ADDENDUM No. 1

PROJECT: Spartanburg Community College
Tyger River HVAC and Boiler Replacements
OSE Project No. H59-6315-JM
DEVITA Project No. 25531

DATE: February 18, 2026

DRAWING NO.
A200

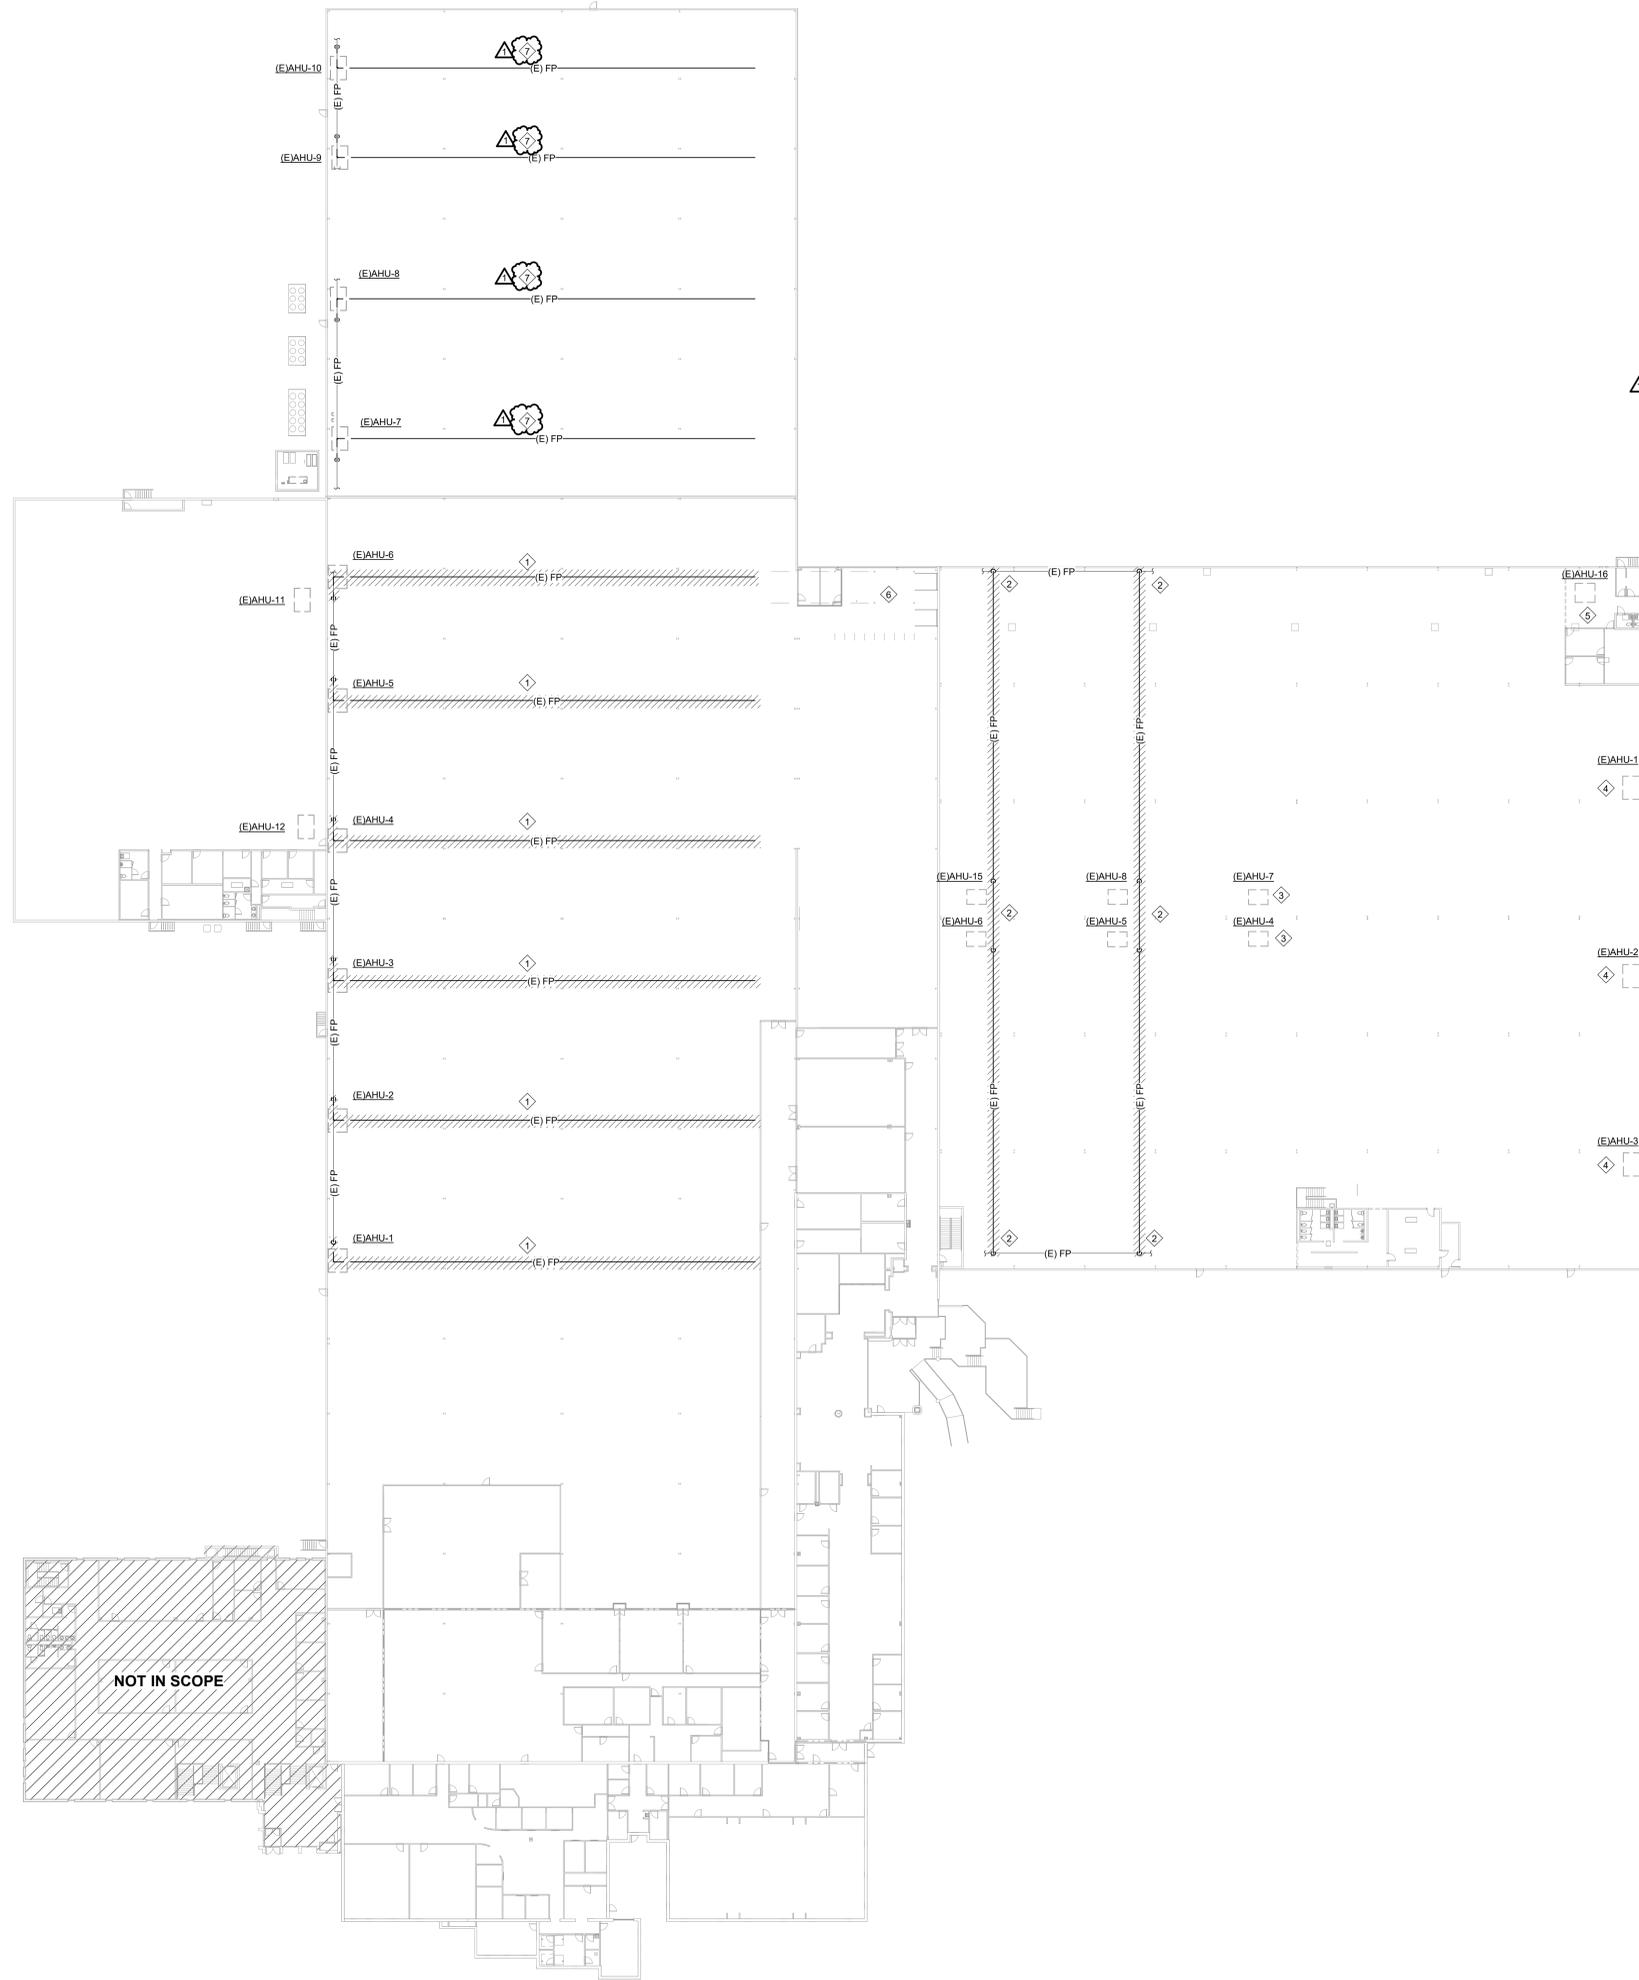
- Demolition scope updated to include more ceiling in the Ready SC area to accommodate medium pressure supply air ductwork installation.

M102

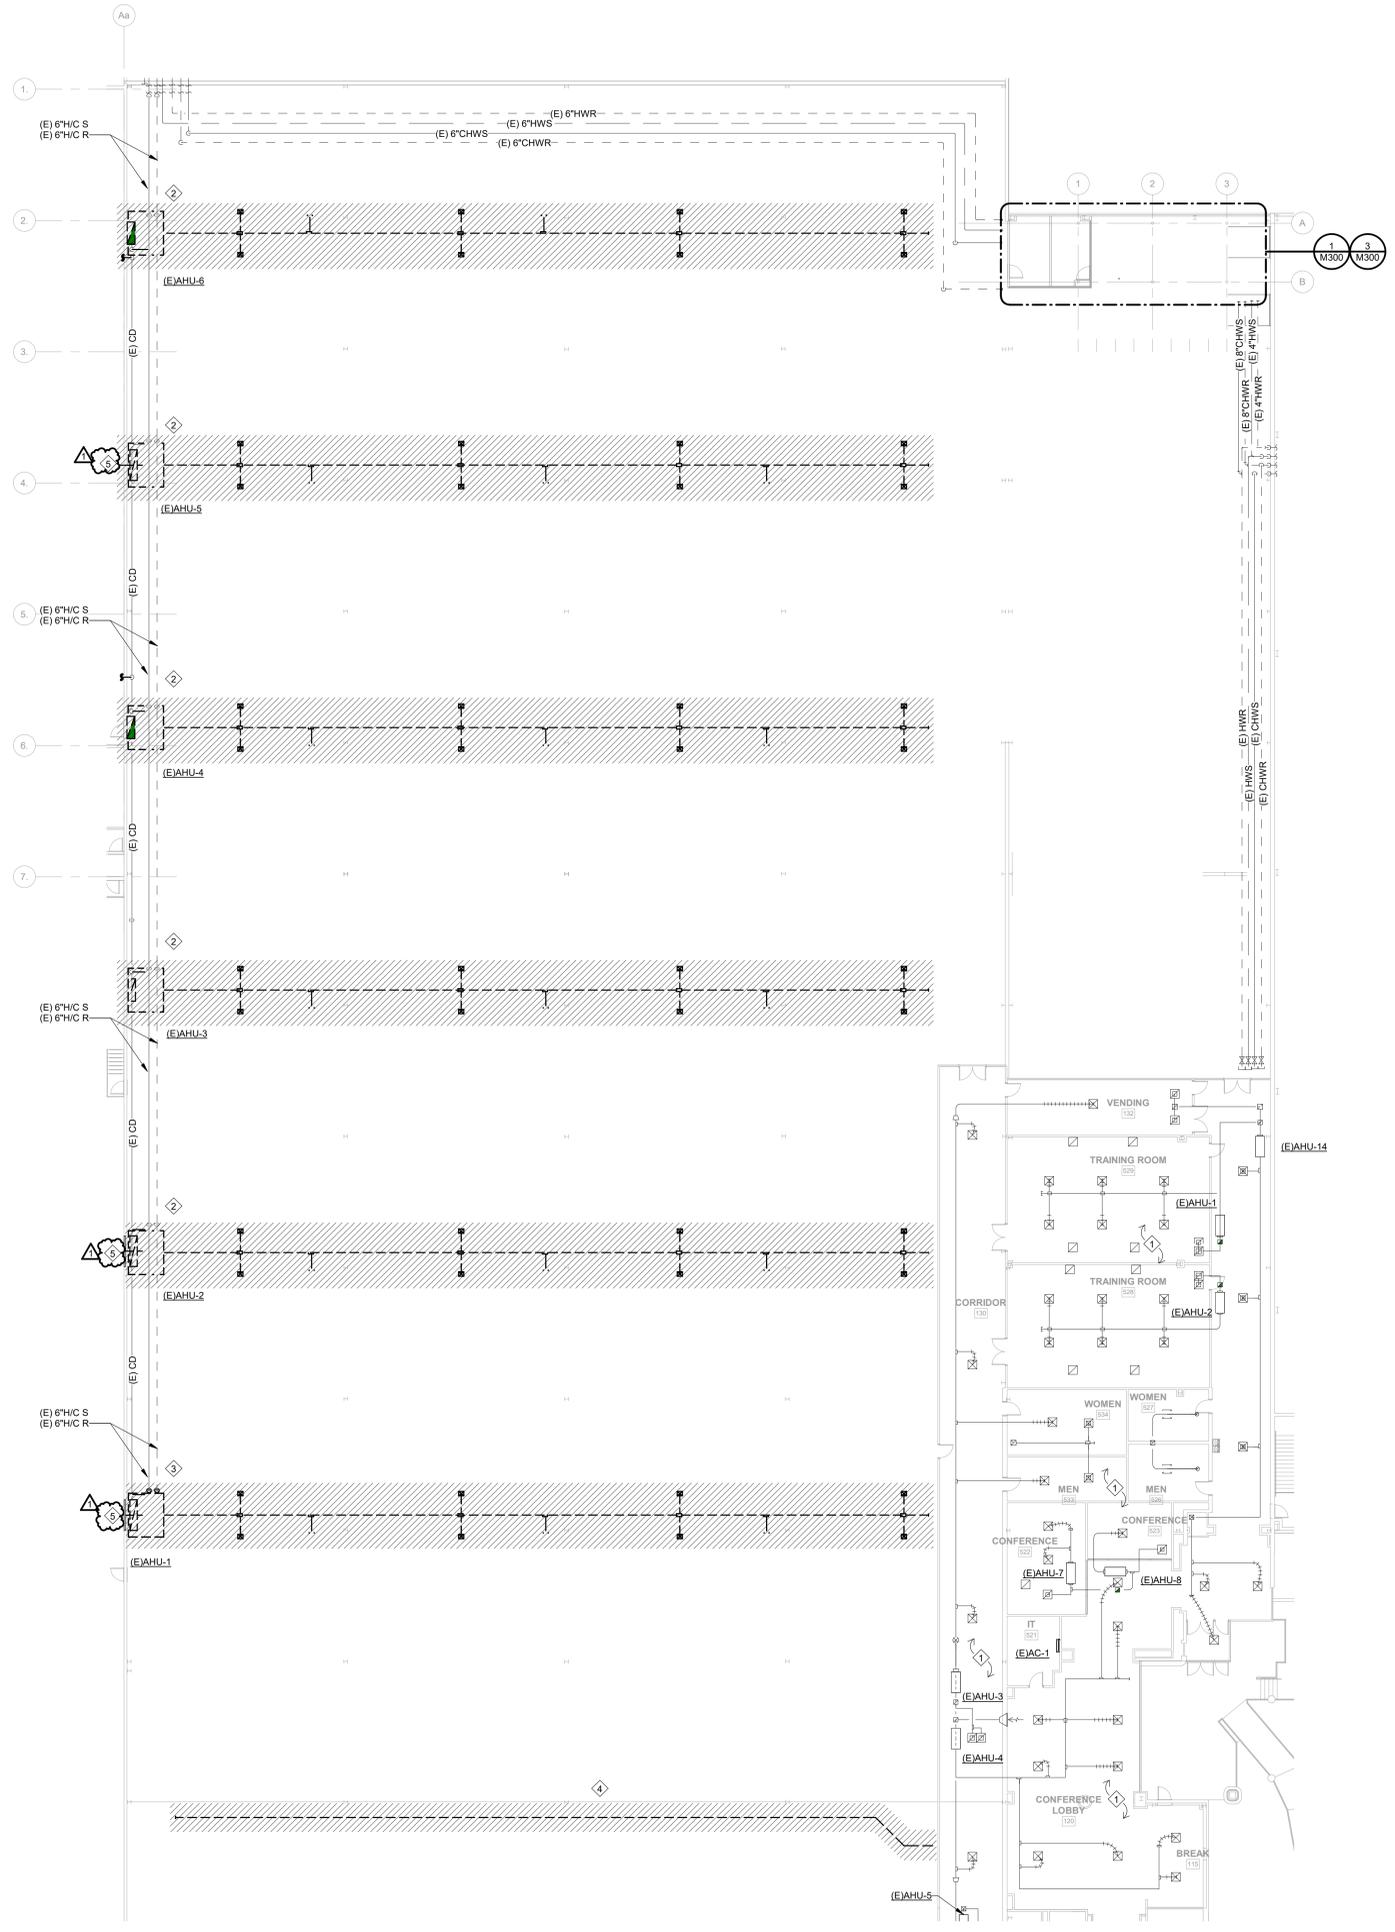
- Added note 5 to cover capping existing outside air louvers.

4. REMOVE ABANDONED OVERHEAD DUCTWORK IN THIS AREA.
5. REMOVE OUTSIDE AIR DUCTWORK ASSOCIATED WITH EXISTING AIR HANDLER BACK TO LOUVER. COVER LOUVER WITH METAL CAP INSULATED WITH 2" THICK INSULATION AND SEAL WEATHER TIGHT.

DRAWING NO.
M105
 Drawn By: ASE Checked By: CIC

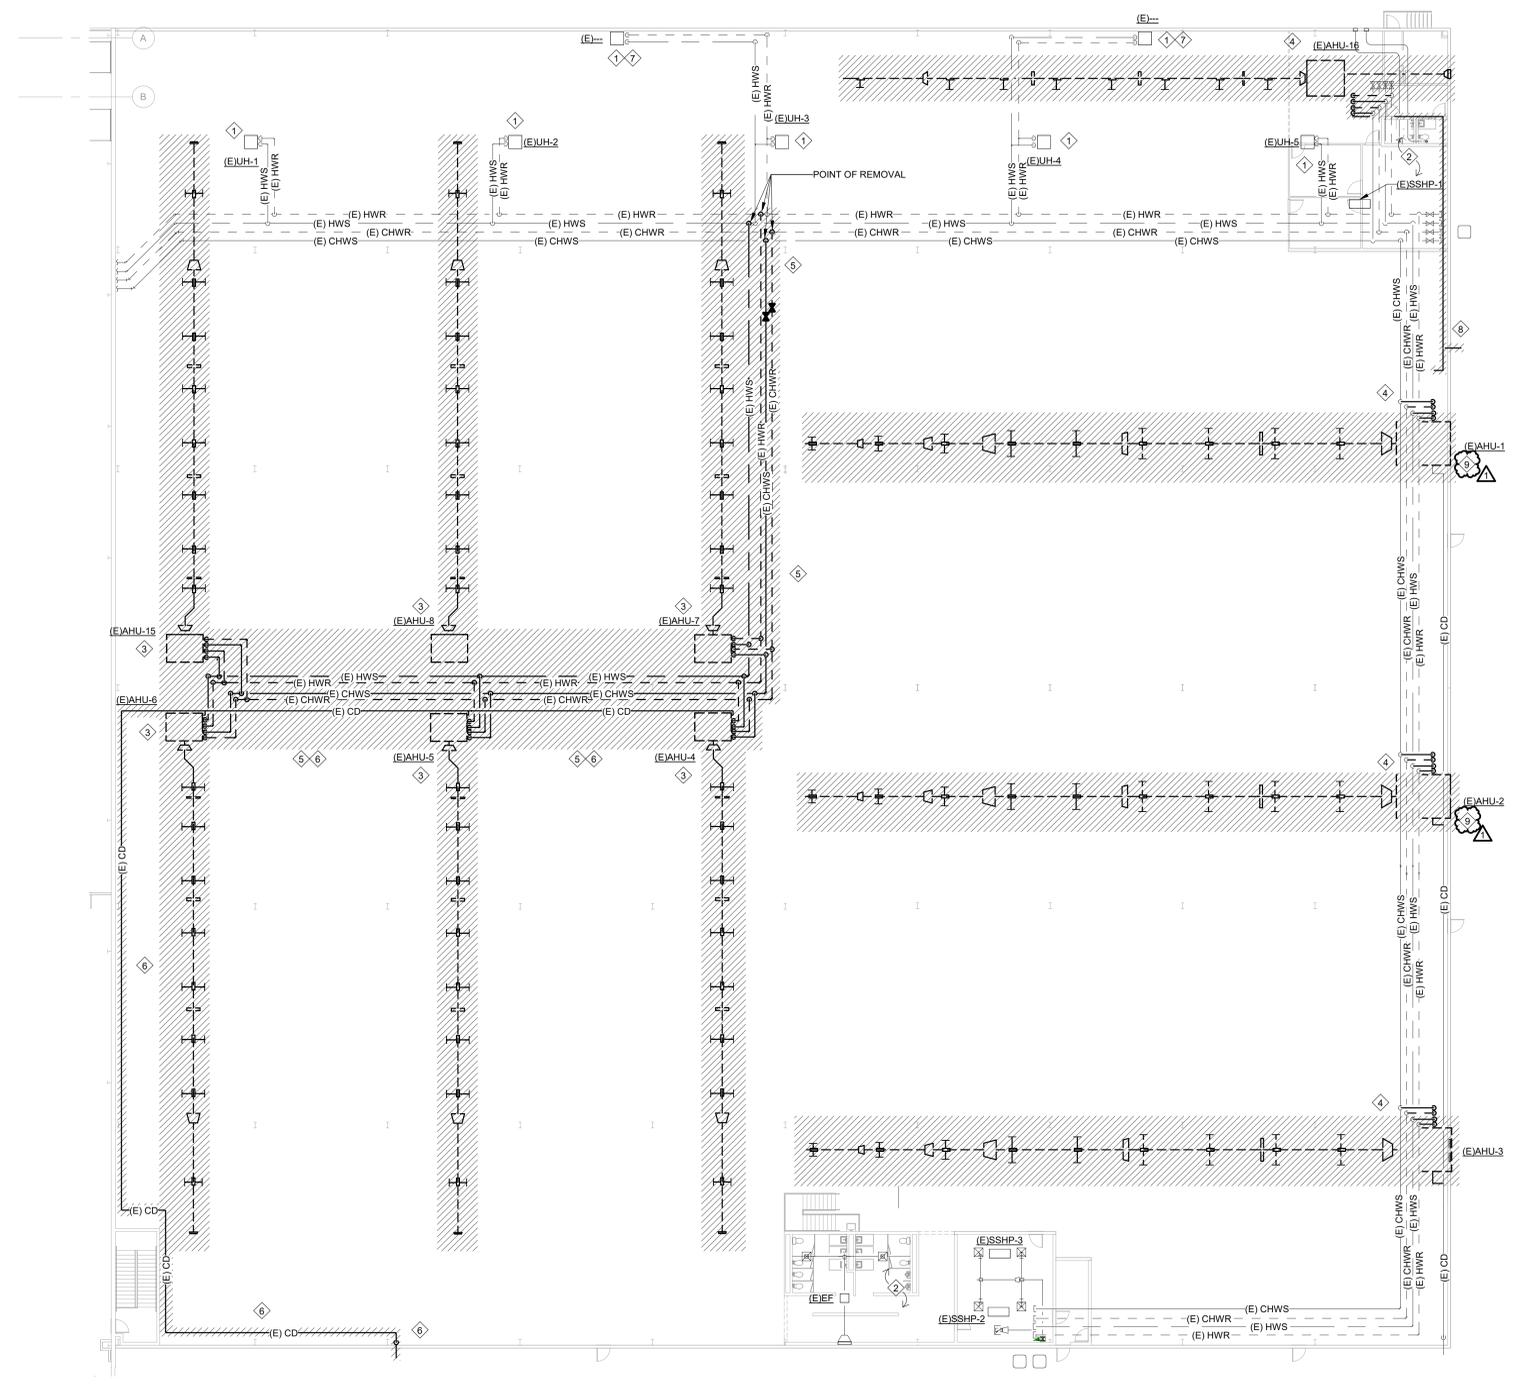
- Added note 9 to cover preparation of existing outside air louvers.
